| U. S. ARMY ENGINEER DISTRICT, NEW ORLEANS CORPS OF ENGINEERS NEW ORLEANS, LA. | | | |

THIS PLAN ACCOMPANIES
MODIFICATION TO
CONTRACT NO. DACW29-
67-C-0196 - P002

PROFILE AND BORINGS

PROFILE AND BORINGS

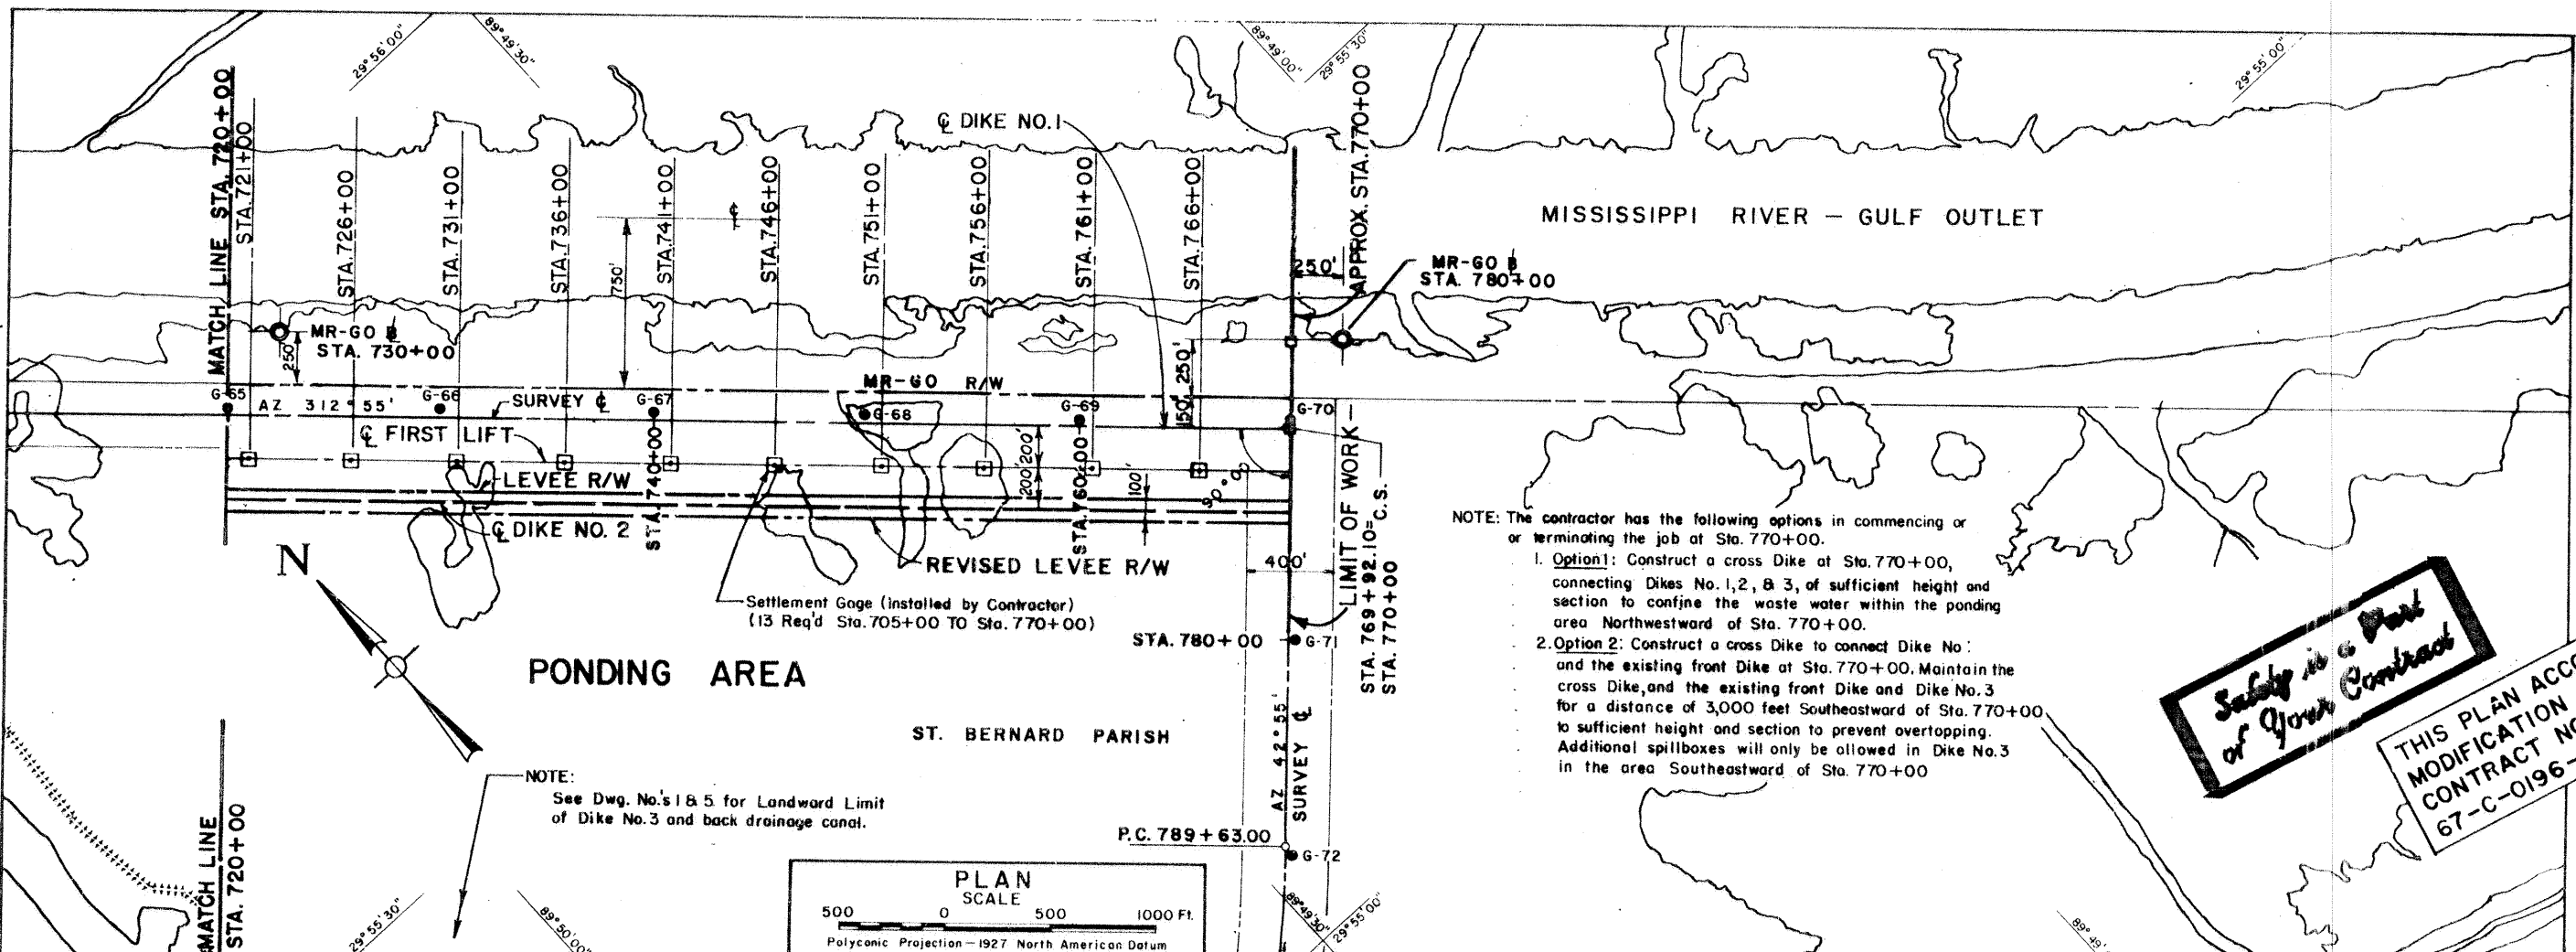
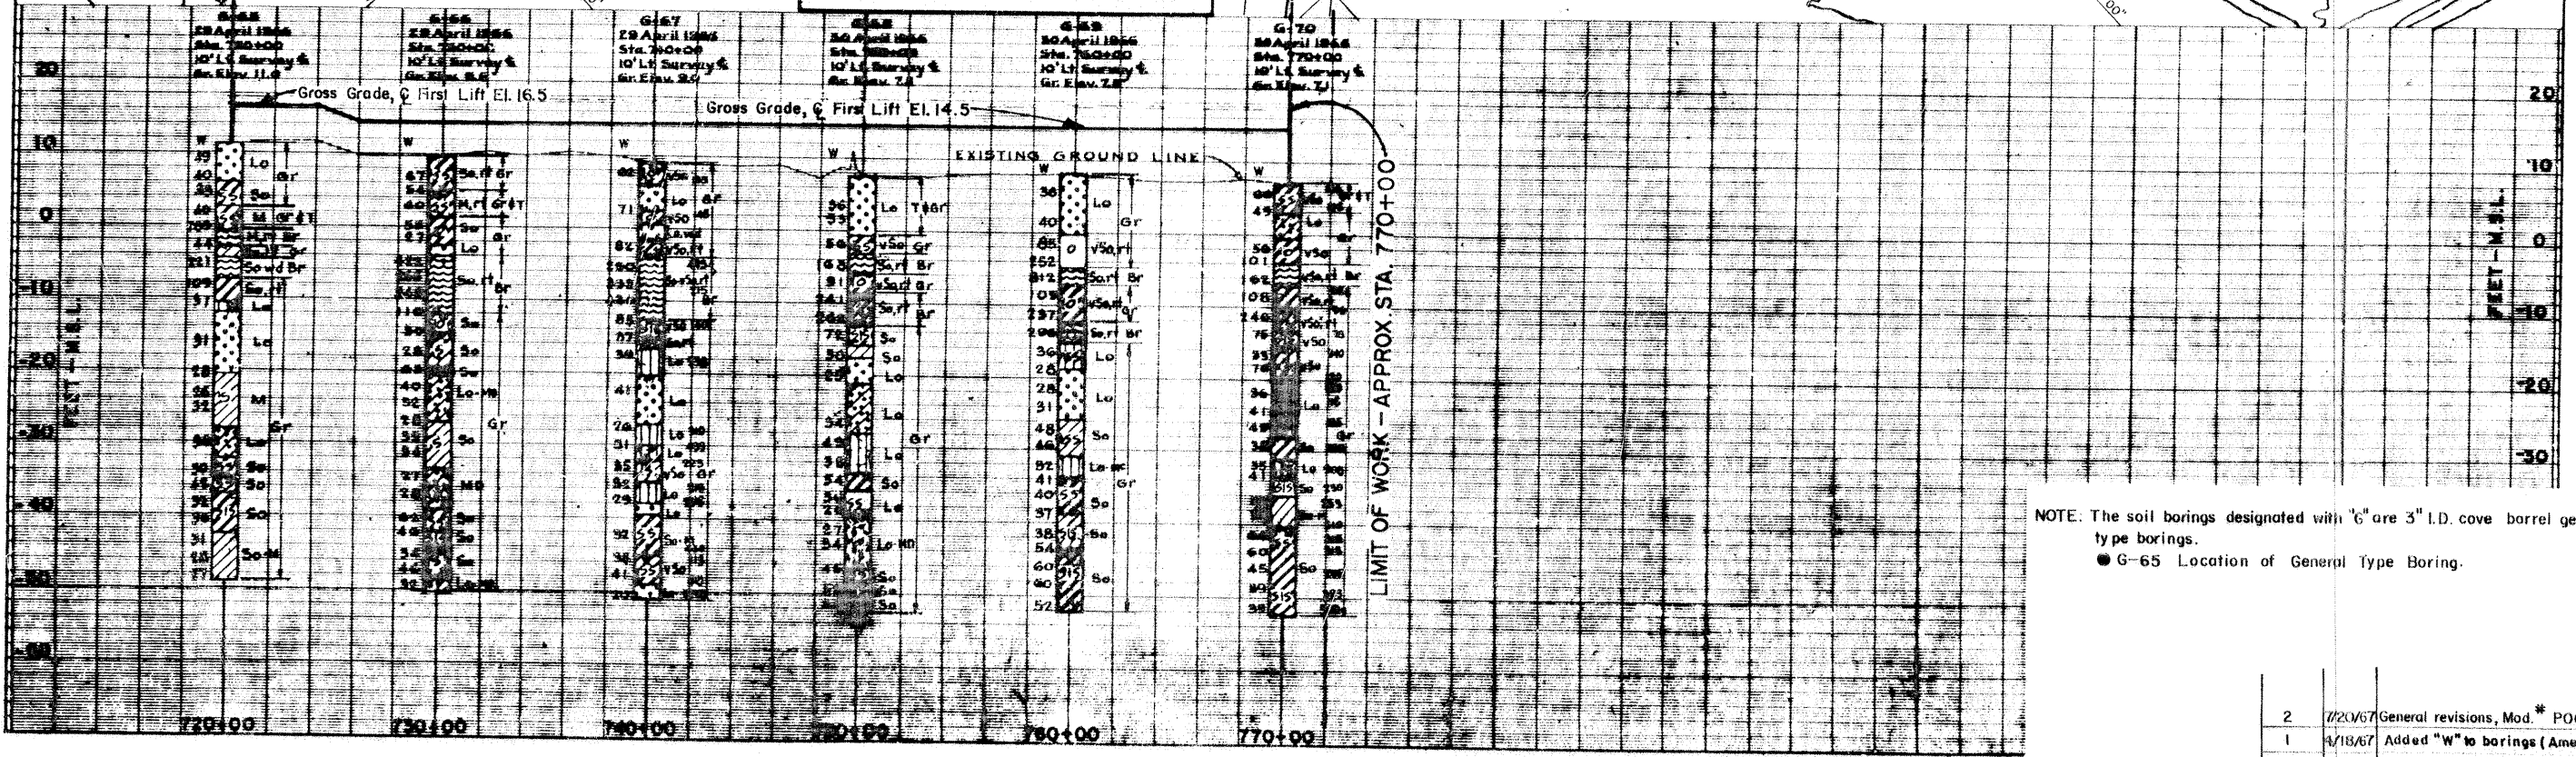
NOTE: The contractor has the following options in commencing or terminating the job at Sta. 770+00.

- Option 1: Construct a cross Dike at Sta. 770+00, connecting Dikes No. 1, 2, & 3, of sufficient height and section to confine the waste water within the ponding area Northwestward of Sta. 770+00.
- Option 2: Construct a cross Dike to connect Dike No. 1 and the existing front Dike at Sta. 770+00. Maintain the cross Dike, and the existing front Dike and Dike No. 3 for a distance of 3,000 feet Southeastward of Sta. 770+00 to sufficient height and section to prevent overtopping. Additional spillboxes will only be allowed in Dike No. 3 in the area Southeastward of Sta. 770+00.

| 2 | 7/20/67 | General revisions, Mod # P002. | D.J.H. |

FIRST LIFT LEVEE EMBANKMENT - DESIGN SECTION

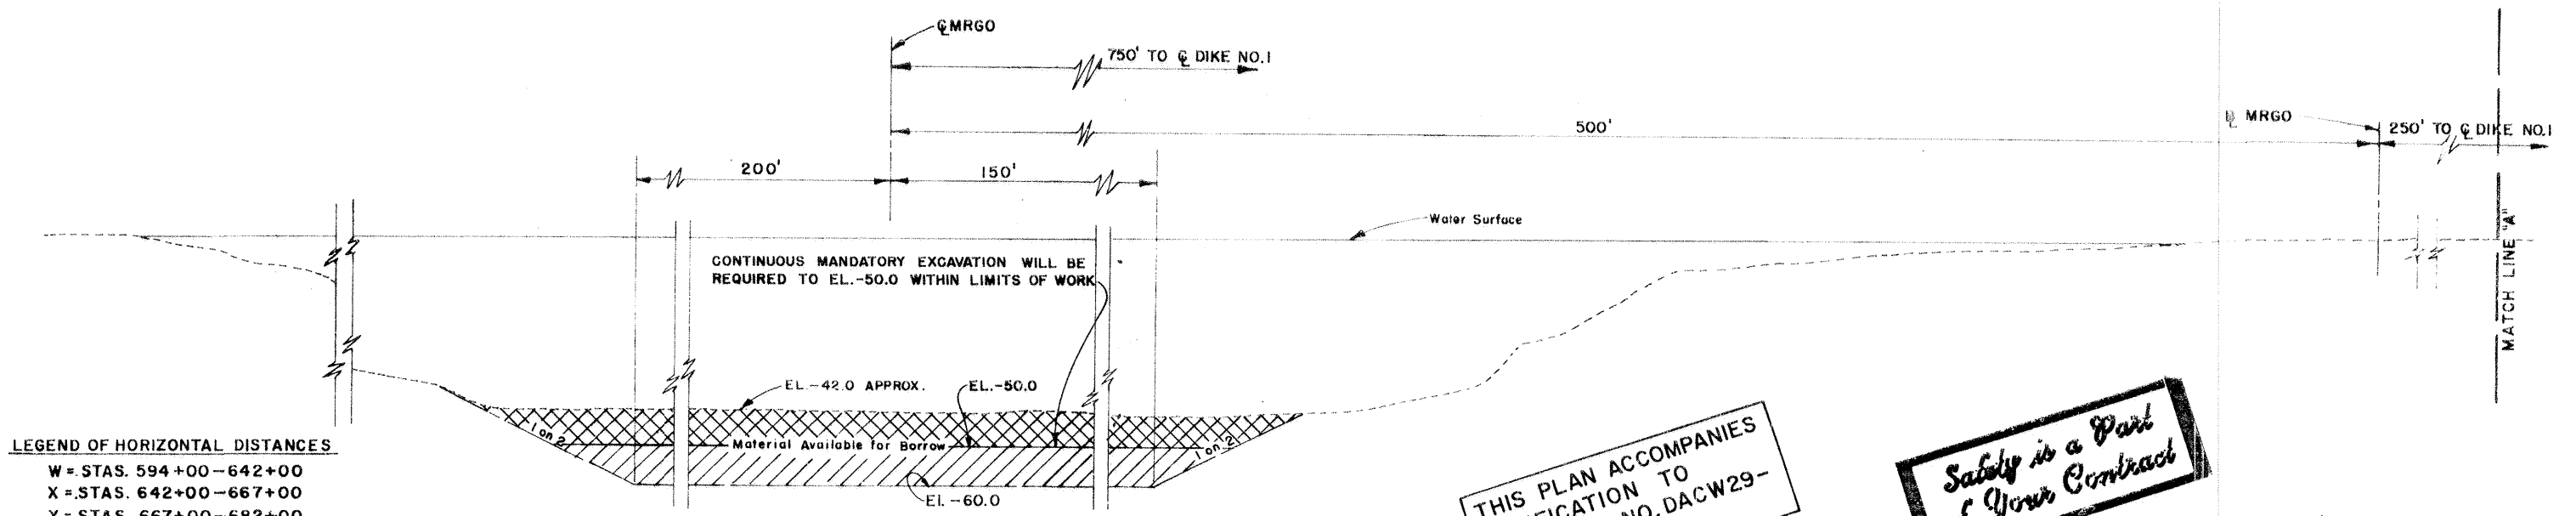
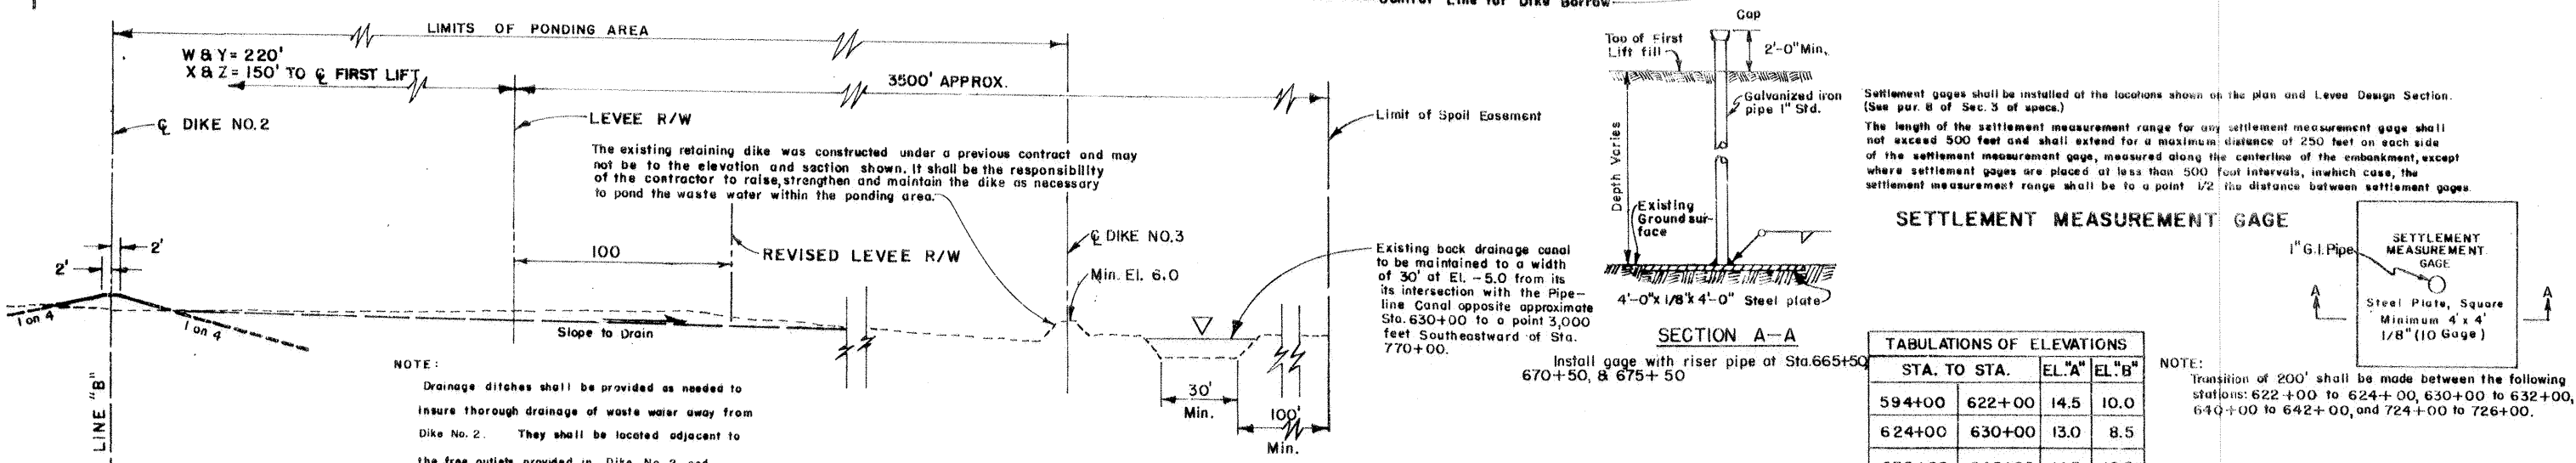
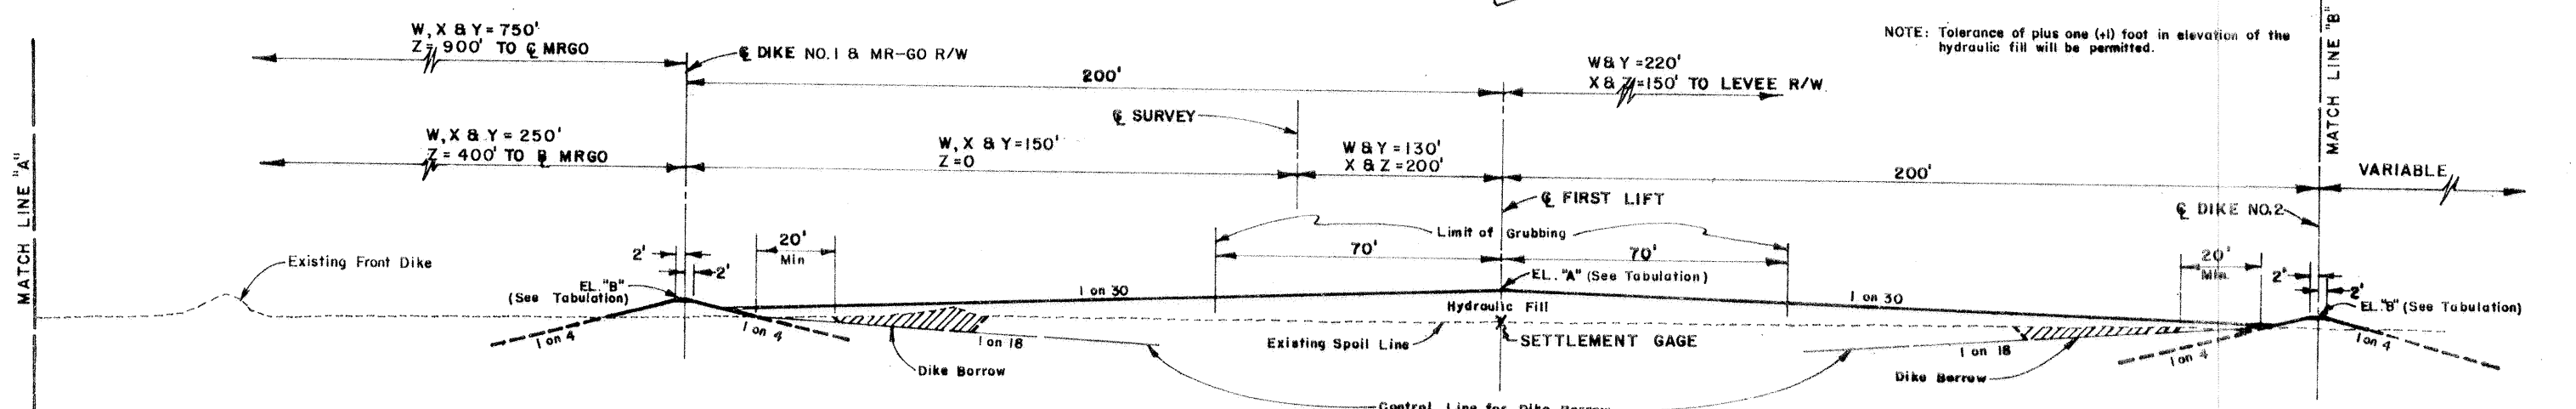
NOTE: Transition of 200' shall be made between the following stations: 622+00 to 624+00, 630+00 to 632+00, 640+00 to 642+00, and 724+00 to 726+00.

| REVISION | DATE | DESCRIPTION | BY |
|----------|---------|---|--------|
| 2 | 2/20/67 | General revisions, Mod # P002 | D.J.H. |
| 1 | 4/18/67 | Added note - transitions (Amend. No. 3) | R.L. |
